SECTOR 1 POPLAR/LEINSTER WEST OF EW

NZS 6806 – Assessment matrix

Mackays to Peka Peka

NOISE PREDICTION
SCENARIOS
SHEET 1 OF 75

MACKAYS TO PEKA PEKA EXPRESSWAY
Sector 1
Leinster Avenue, West of Expressway
Mitigation Option 2

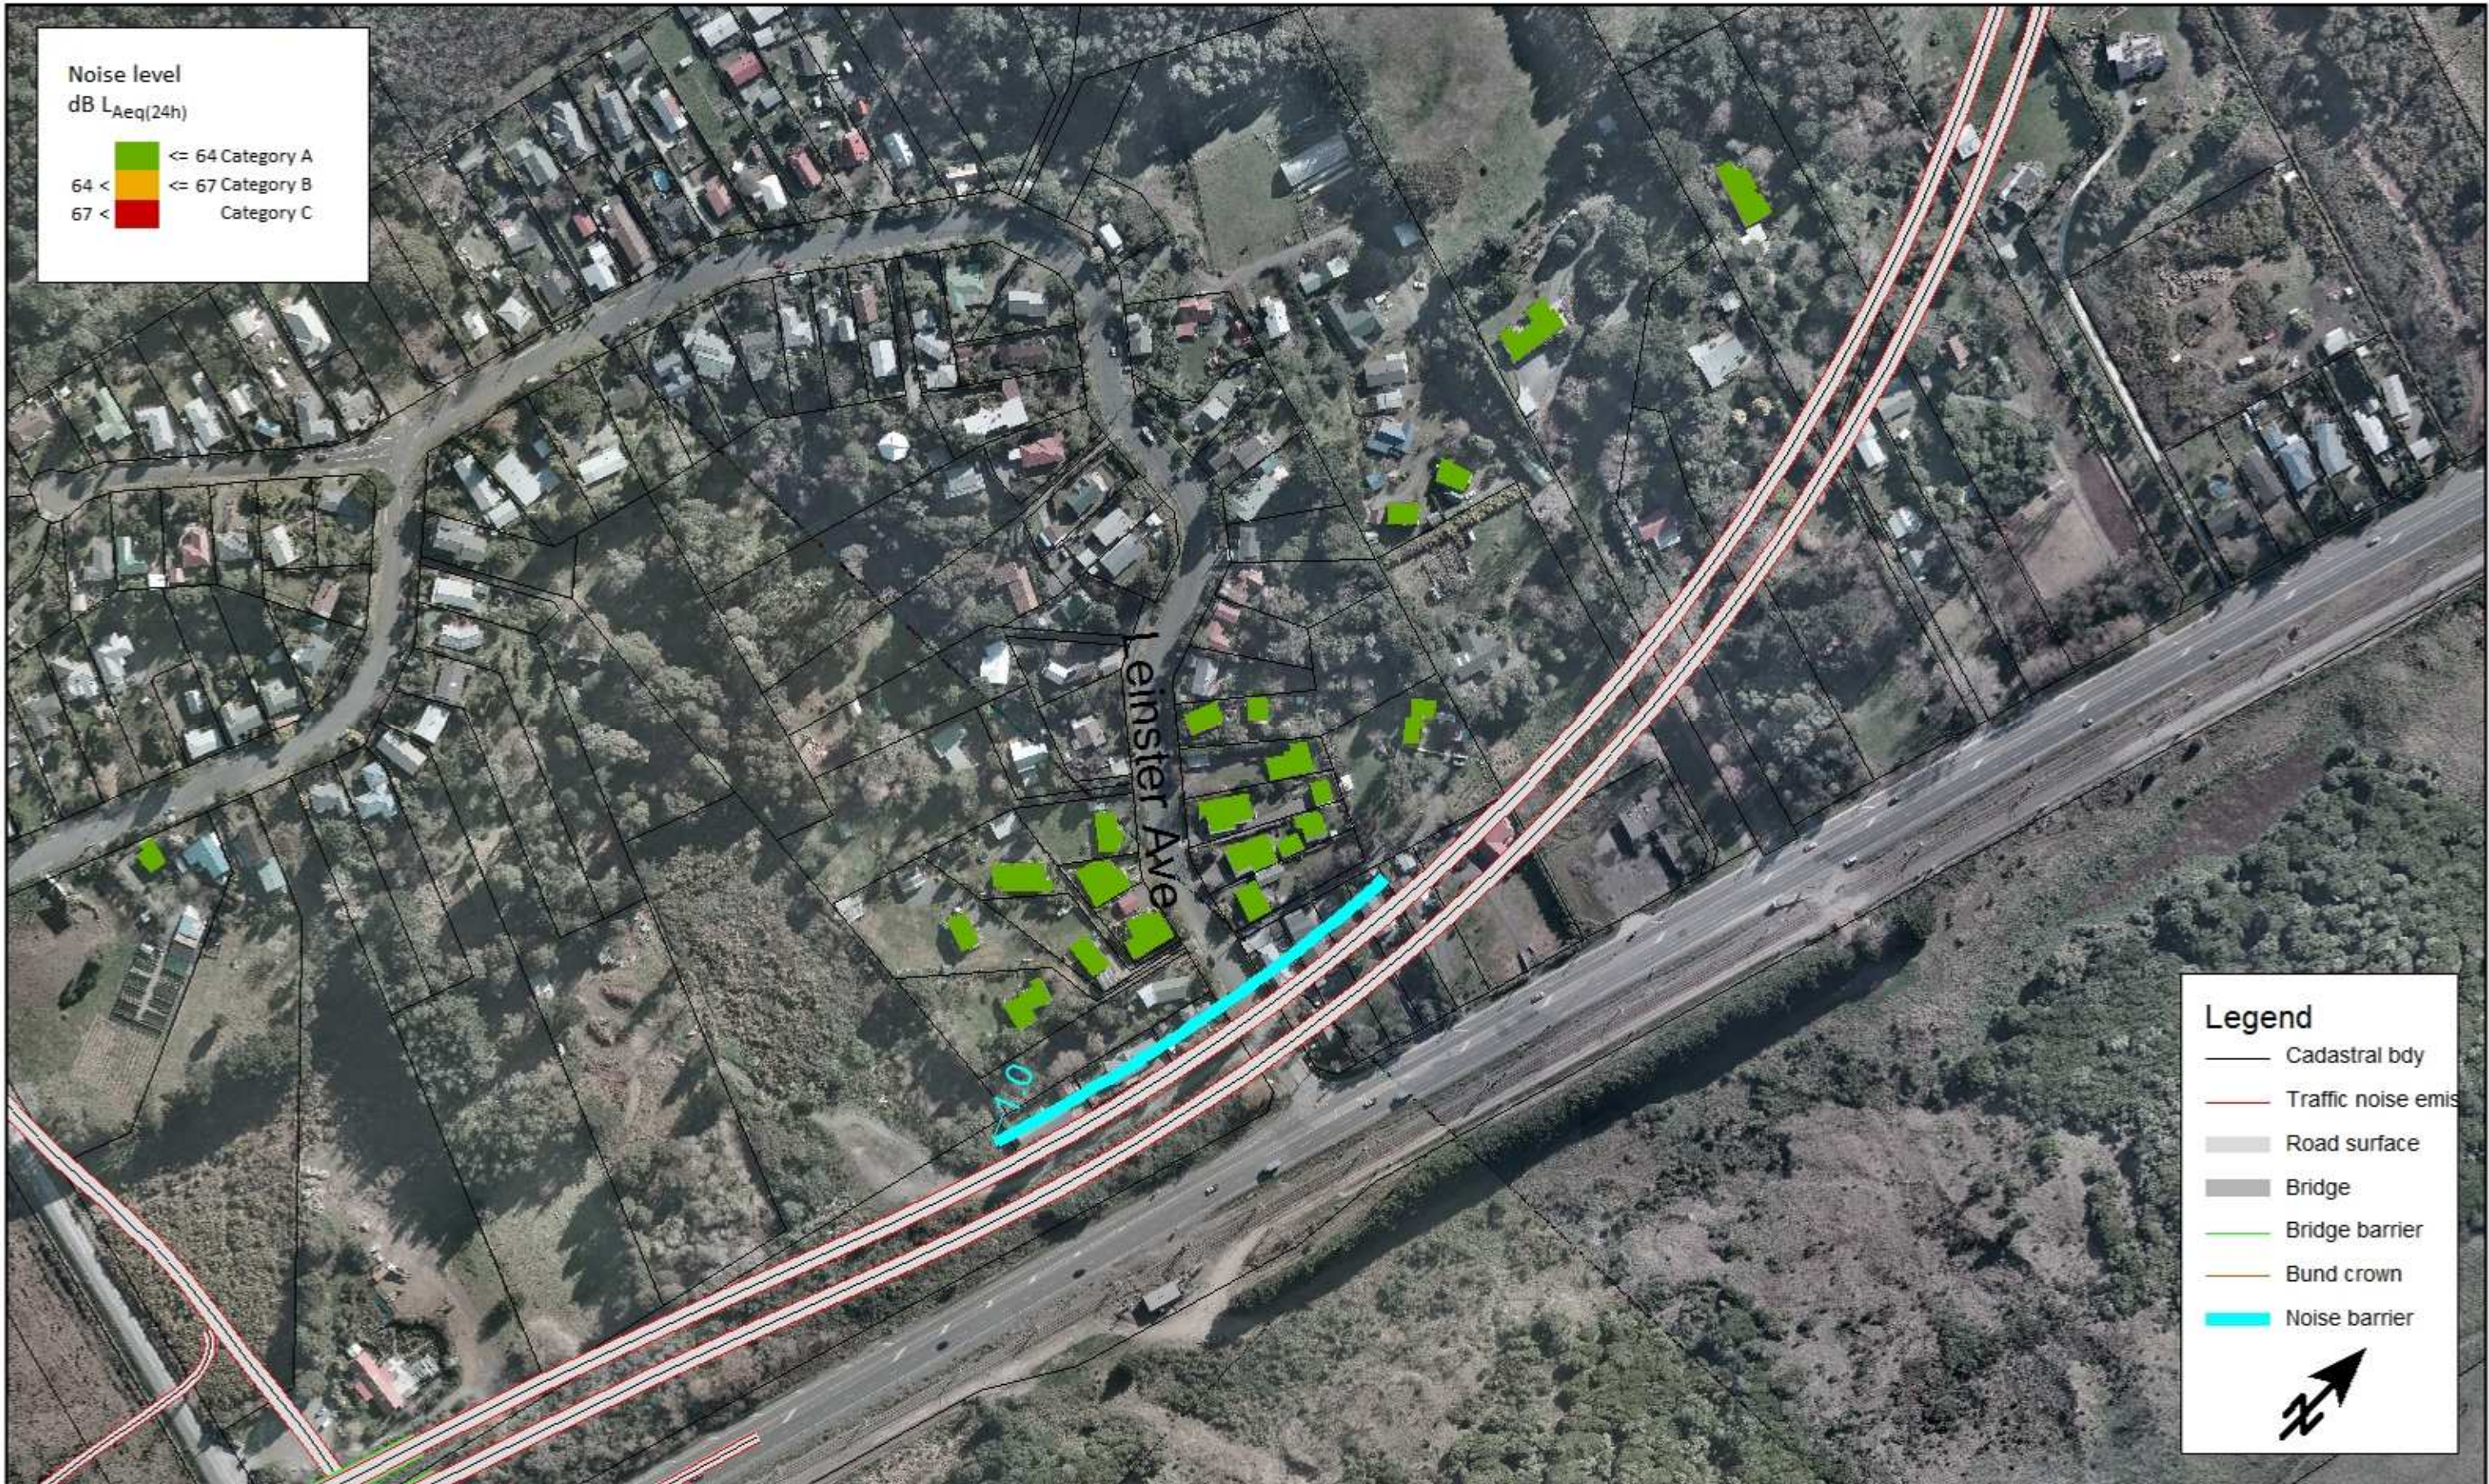
Assessment Criteria	Responsible	Option 1	Option 2	Option 3	Option 4 – Bund only	Issues/Risks
Compliance with relevant safety standards and guidelines	Roading	0	0	0	0	All meet standards
	Structures	0	0	0	0	Can be designed
Constructability/technical feasibility	Roading	-2 bund	-2	-1	0	Based on fence on bund Option 4 preferred
		0 bund/fence combo	0 bund/fence combo	1 bund/fence combo		
	Structures	0	0	0	1	Option 4 preferred
		Construction	-2	-2	0	1
Availability of sufficient land for construction and maintenance and the extent to which NZTA would need to acquire land, or interests in land	NZTA	-2	-2	0	0	Ian to check
Potential effects on known heritage or cultural values	Cultural	?	?	?	?	No representative present- needs input
The extent to which the mitigation option promotes integration and establishes visual coherence and continuity in form, scale and appearance of structures and landscape proposals along the route	Visual / landscape	-2	-2	0	0	Better to have higher bund than bund plus fence. Could integrate a 1m wall on bund but any higher would have adverse effects on properties

-1 bund only	-1 bund only	0 bund only	0 bund only	
Road users' views to the surrounding landscape and key features/ locations in particular	Visual / landscape	0	0	0	0	
Maintenance or enhancement of	Visual /	Bund +1	Bund 0	Bund 0	Bund 0	Don't want to look on to

Assessment Criteria	Responsible	Option 1	Option 2	Option 3	Option 4 – Bund only	Issues/Risks
visual amenity for surrounding residents	landscape	Bund/Fence combo -2	Bund/Fence combo -2	Bund/Fence combo -1	Bund/Fence combo 0	other peoples back yards. Existing bund with planting will be effective to resolve this.
Utilisation of materials that reflect the character of the location	Visual / landscape					Bund preferred to as it reflects environment and enhances amenity.
Maintenance or enhancement of the convenience and attractiveness of pedestrian and cycle networks	Urban design	-2 Bund/fence combo	-2 Bund/fence combo	0 Bund/fence combo	0 Bund/fence combo	Depends on wall type – some better than others.
		-2 bund	-2 Bund	0 Bund	0 Bund	
Impacts (land take, amenity and usability) on community facilities (reserve, school, playground, playing field, etc)	Urban design	0	0	0	0	
Public safety and security	Urban design	-2 wall	-2 wall	0 wall	0 wall

Preferred Mitigation Option 4 (Do-min with the existing bund and low noise road surfacing already in the model)

OR 1m wall on top of existing bund (which only provides 1 dB difference).

Graphs

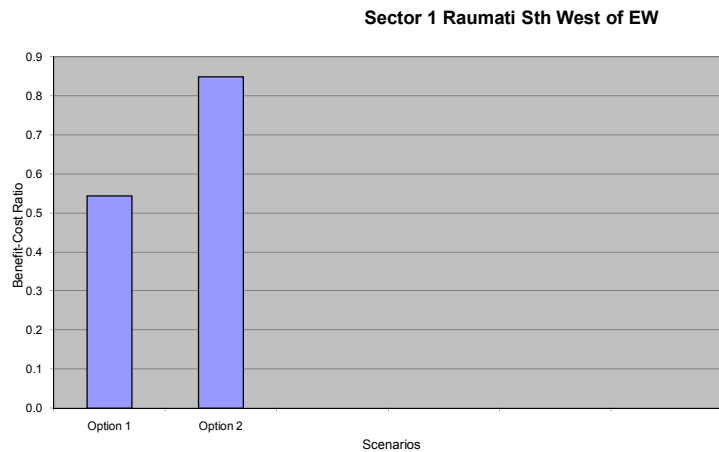
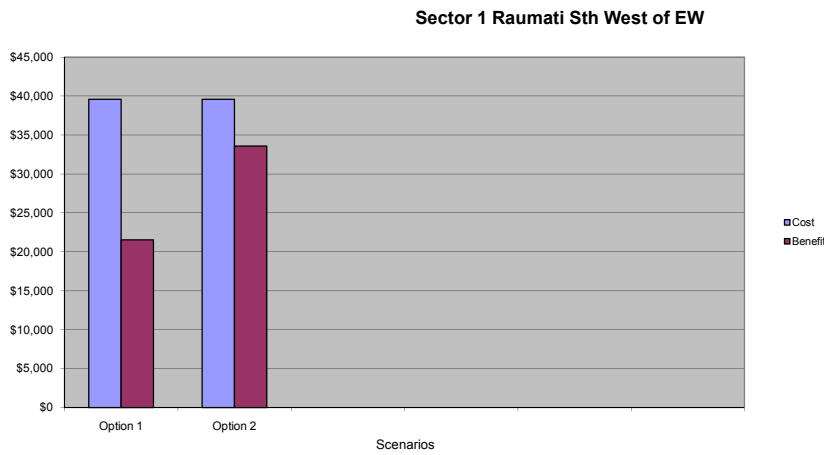
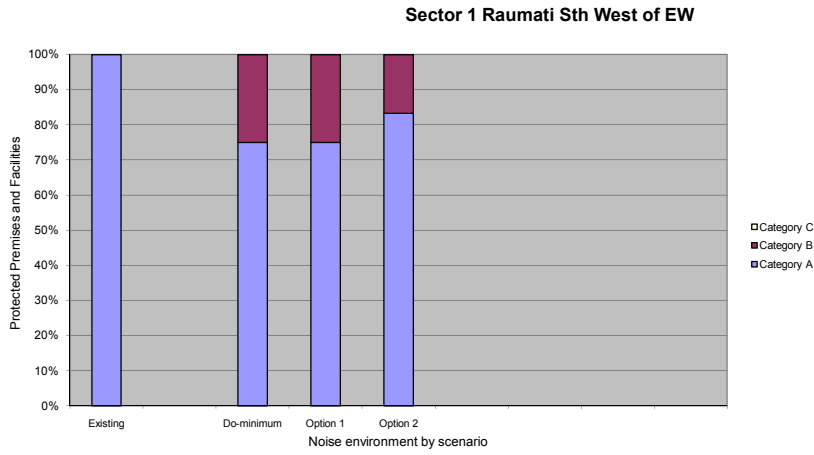
Final Comment: Option 4 (Do-minimum) preferred because less visual impact than barrier on bridge. Barrier offers insignificant noise reduction at this location.

Questions: Could a wall be put up against boundary of the Yellow category house? Siiri responded that she could not find a suitable solution given that it is a two storey dwelling.
